SUBJECT: Forwards responses to Structural Engineering Branch Round 2,
Set 1 questions re sacrificial shield wall.

Subject: WPPSS Nuclear Project No. 2
Responses to Round Two Questions
Set One, Structural Engineering Branch (SEB)
Concerning the Sacrificial Shield Wall

Responses to Round Two Questions Set One,
Structural Engineering Branch (SEB)
Concerning the Sacrificial Shield Wall

WNP-2

Fig. 130-45-1

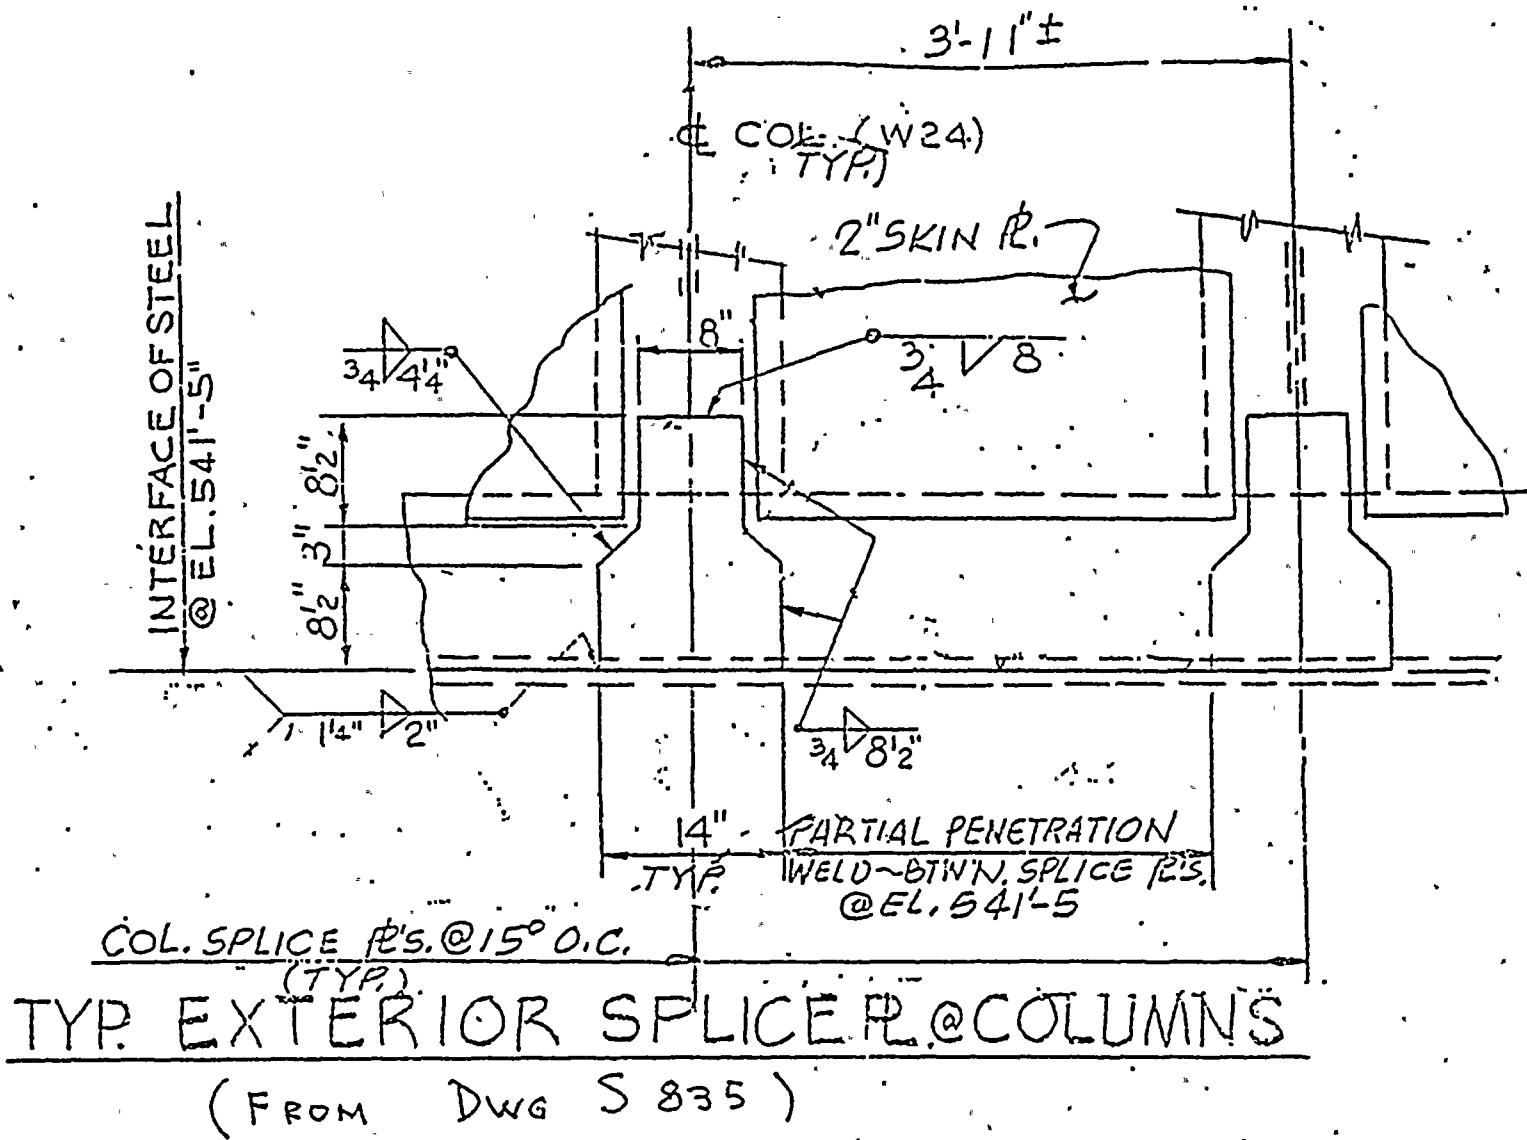
Provide typical welding details for the column splice plates, the skin plates, and the shim plates at the construction joint in the sacrificial shield wall (SSW) at elevation 541'-5". These details should include the size and length of welds and an indication whether the welds are continuous or intermittent. Indicate the maximum total loads which are transferred at this joint.

- a. Typical welding details for the column splice plates are shown on B&R Drawing S835 included in Reference 1, Attachment 5. Welding details for the exterior splice plate are shown in the detail entitled, "Typical Exterior Splice Plate at Columns" and consist of the following: (See Fig. 130.45-1 - from Dwg. S835 for convenience)

Above the interface, El. 541'-5", the splice plate is welded to the W24 column and the ring channel by 50.5 inches of 3/4 inch fillet weld.

Below the interface, the splice plate is welded to the ring box by a complete penetration single bevel weld, 2 inches by 14 inches.

FIG. 130.46-1

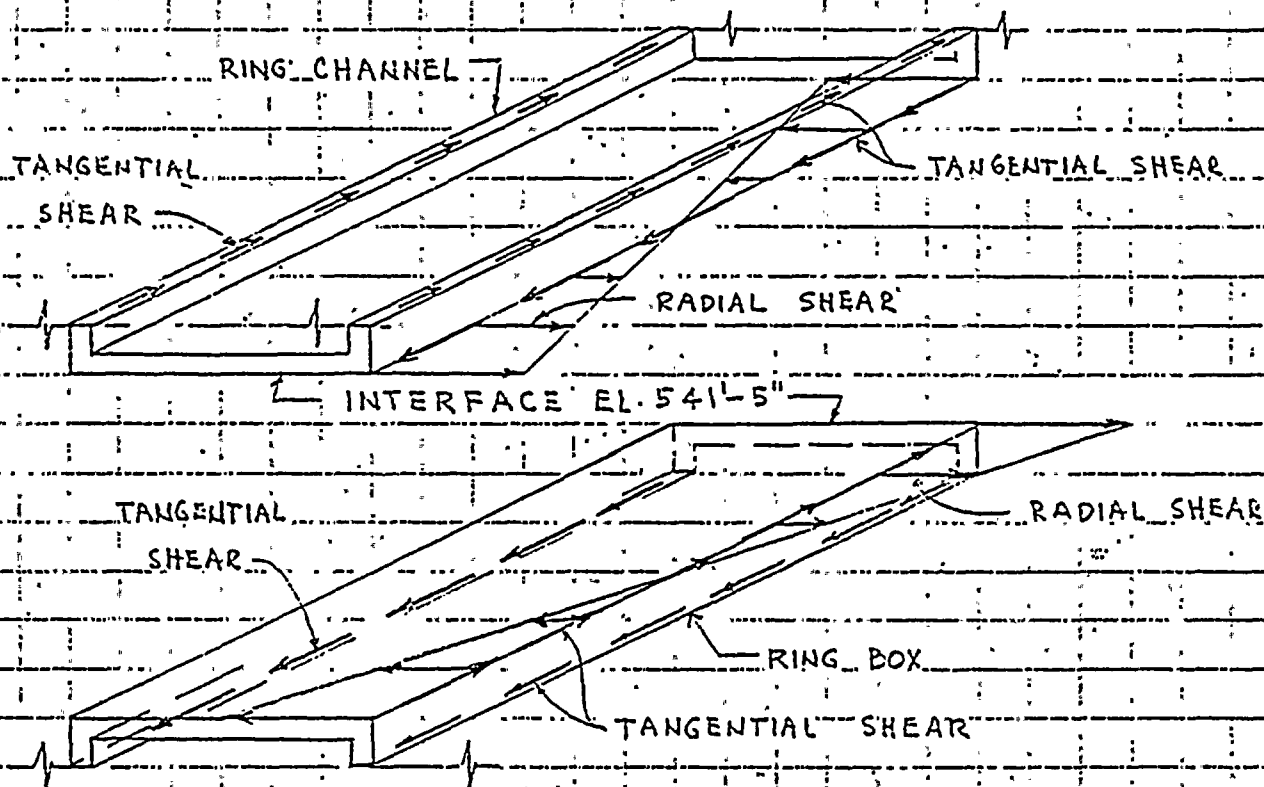
The tangential shear in the ring channel above and below the 541' construction joint in the SSW is taken up equally by the inner and outer skin plates while your proposed corrective weld is only on the outer skin plate. Accordingly, describe the redistribution of loads at the 541' construction joint. Identify the structural elements which resist the localized bending moment due to this "side-stepping" of the tangential shear introduced by your proposed corrective weld at this construction joint. Explain in detail how all the structural loads are transmitted to the box ring below this construction joint.

This request is concerned with the method of transmission of tangential shear from the ring channel above the joint interface at Elevation 541'-5" through the corrective weld at the interface and then into the ring box below the interface. To clarify the transmission of the shear and the redistribution of forces that occurs at the interface, a sketch showing the forces acting on the ring channel and on the ring box for one 15 degree panel of the wall is enclosed as Figure 130.461.

- a. The redistribution of loads at Elevation 541'-5" is shown in the sketch. As shown thereon, symmetrical tangential loads from the upper wall are applied from above equally on the interior and exterior flanges of the channel. These symmetrical tangential forces on the channel are equilibrated by a set of forces along the lower exterior edge of the channel applied through the correction weld. This equilibrating set of forces consists of a uniformly distributed longitudinal force and a distributed radial force whose magnitude varies linearly between extreme values at the ends of the weld. In effect, the equilibrating set is statically equivalent to the applied symmetric forces acting in the reverse direction.

- b. The preceding redistribution of upper symmetric forces on the channel into asymmetric lower forces at the interface occurs in reverse for the ring box. Thus, the asymmetric forces acting at the top of the box are converted into symmetric shears in the side plates of the box member; these symmetric shears are transmitted to the lower wall. The asymmetric set of forces from the correction weld consist of the same uniform longitudinal force and varying radial force as above but acting in the opposite direction on the upper exterior edge of the box. The equilibrium of the box member is then maintained by uniformly distributed longitudinal forces of equal magnitude acting on the interior and exterior side plates of the box.

- c. The preceding description and Fig. 130.46-1 show that the channel and box members above and below the interface are each subjected to bending moments about the vertical axis. Analysis has been made to determine the resultant stresses in the members; the analysis is done ignoring the continuity of the members beyond the panel in question. Since the box member has substantially larger sectional properties than the channel, calculations were made for the channel member only. These calculations together with the associated calculations for the equilibrating forces in the correction weld were transmitted to NRC in Attachment 4 of Reference 1 and are included here as Figure 130.46-2 for convenience. As indicated in the calculations, the resultant bending and shear stresses in the members (shear - 9.9 KSI, bending - 0.8 KSI), are low and are well within permissible values.
